Access Compliance Report Public Rights-of-Way (Curb Ramps)

Main Street: N/A Cross Street: NEWPORT_AVE Location: NE

ADA ID: RPAT220222134314 Ramp Type: Type 4 - Parallel Initial Pass/Fail: Fail Overall Compliance: No Severity Score: 16

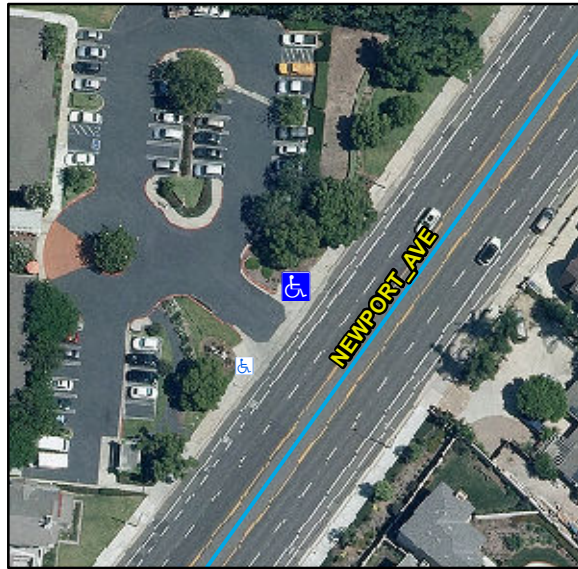
Remove & Replace Entire Ramp. Grind Gutter Lip.

R304.3.2, R304.5.3, R302.7.2, STD 1115
